Tutt Avenue & Rugby Street Intersection Upgrade

Consultation Report 2024

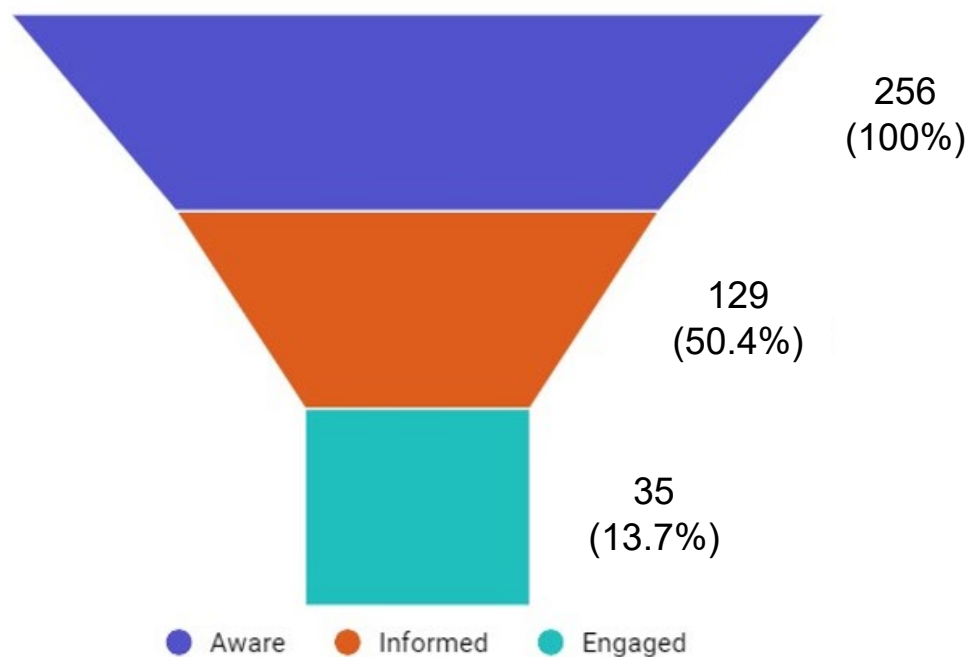
- Support for the overall design – **19 respondents.**
- Restrict additional car parking to improve visibility – **7 respondents.**
- Recommend reducing the speed limit to 40km/hr – **5 respondents.**
- Other – **4 respondents.**
- Not in Support of Flashing LED Stop Sign – **3 respondents.**
- Recommend Installing Raised Intersection – **2 respondents.**
- Recommend Installing Roundabout – **1 respondent.**

Suggestion 1: Restricting additional car parking near the intersection to improve visibility.

Suggestion 2: Recommend implementing a 40 km/h speed limit.

It is proposed as part of the upgrade that a single car parking space is removed on each side of Rugby Street to maintain a balance between improved visibility and preservation of on-street parking. The intersection upgrade will improve visibility (sight lines) and will comply with current Australian standards. The Council aims to achieve a safe balance between on-street parking and road safety. Since the upgrade will meet the required visibility standards, additional car parking restrictions will not be necessary.

The Council must obtain approval from the Commissioner of Highways through the Department for Infrastructure and Transport (DIT) to implement a 40 km/h speed limit, which must apply to a local area rather than an individual street.

Approval criteria for the installation of a 40 km/h speed limit includes: a clear boundary definition of a 40 km/h precinct and a review of mean average speeds for all streets within the defined boundary. This requires the conduct of speed surveys on all relevant streets within the precinct, consultation with all affected residents, businesses, and adjoining councils, identification of those streets or sections of street which are to receive new high-level physical speed control treatments, or which are to retain a 50 km/h speed limit and installing appropriate signage and treatments. Government requirements emphasise that this speed limit applies to a complete precinct, not just a single street.
